SUBJECT: COA-22-040 (ZON-22-115) 801 S COUNTY ROAD (COMBO)

MEETING: JUNE 21, 2023 LPC

The applicant has submitted plans, entitled "CABANA RENOVATION 801 SOUTH COUNTY RD", as prepared by **LaBerge & Menard Inc.**, dated May 30, 2023.

• Renovation and addition to existing beach cabana.

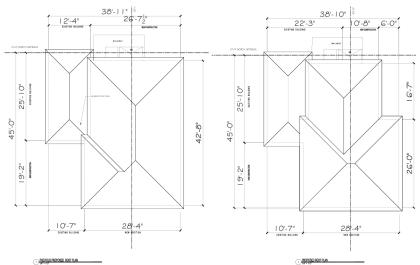
As it pertains to Variance #1, the existing cabana has a nonconforming west street setback of 10'-5" in lieu of the 35' setback required. Due to demo of greater than 50% as part of the renovation, the nonconforming setback must be revested.

Previously proposed roof/floor plan on left, proposed on right.

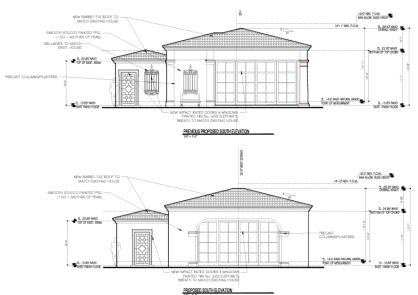
Building mass was removed from north east corner of the building, reducing the proposed floor area by approximately 115 sq. ft.

Previously proposed south elevation at top, currently proposed at bottom.

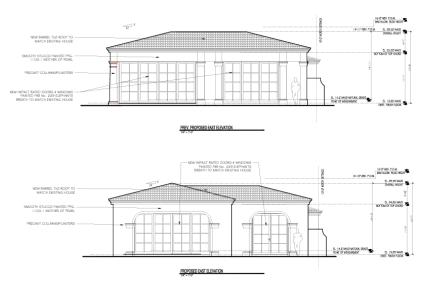
On the south elevation, several changes were made to simplify the elevation and match the primary landmark structure. Precast columns are now modified to be incorporated into an arch surrounding the glass doors centered on the new addition, the windows with grillwork are now omitted, and the entry door is now centered on the northwest portion of the building.

Previously proposed east elevation at top, proposed at bottom.

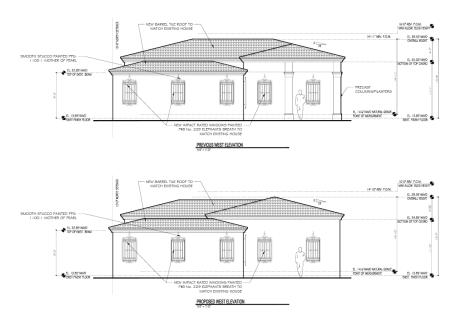
On the east elevation, the large glass doors have been reduced, and the arch detail from the south

elevation is continued and incorporated onto each entry. The northern portion of the addition is stepped back, modifigying the expansive single-dimension elevation previously presented.

Previously proposed west elevation at top, proposed at bottom.

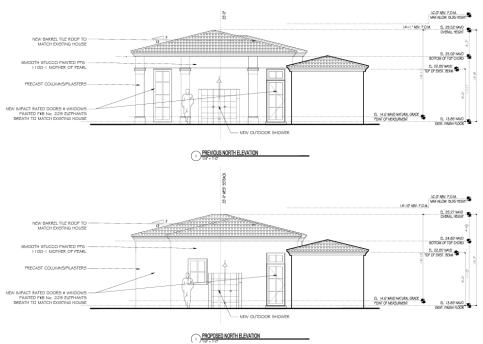
The west elevation remains largely unchanged, aside from the elimination of previously proposed precast column details.
